**DEVELOPMENTAL SPECIFICATIONS  
FOR  
PCC PAVEMENT NON-DESTRUCTIVE THICKNESS DETERMINATION**

**Effective Date  
April 17, 2018**

**Replace** all of Articles 2301.04 and 2301.05 of the Standard Specifications with the following. Differences from the Standard Specifications are highlighted.

Figure1. Target Location

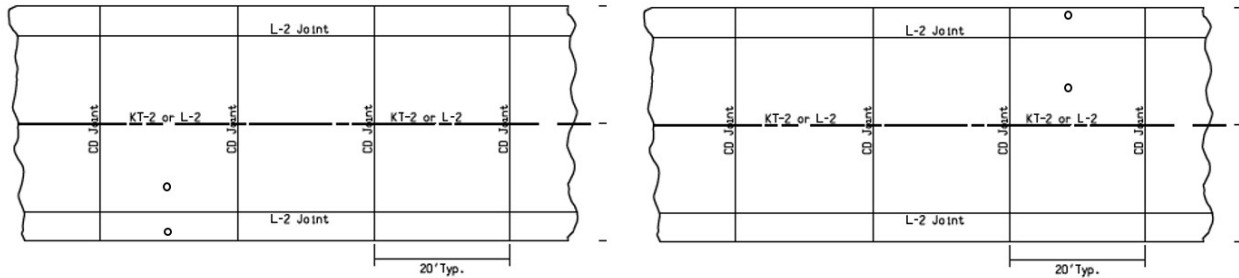
1. Divide the section longitudinally into 200 foot long lots. One target will be located in each lot based on the spreadsheet selection. Beginning with the first station at +00, place a target from the edge of the pavement (The targets should be placed half way between dowel baskets). See Figure 1. If the +00 station falls on a basket, move the target location ahead halfway between the dowel baskets. A minimum of ten targets will be tested. If a target location falls on a bridge or in an approach section, it will be eliminated.

2. The transverse location of the targets will be randomly determined by the spreadsheet program. The random locations will be either 6 4 or 10 8 feet from edge of pavement left or right of centerline. When tie steel is present at the edge of the pavement or lane, the locations will be 5 or 9 feet.
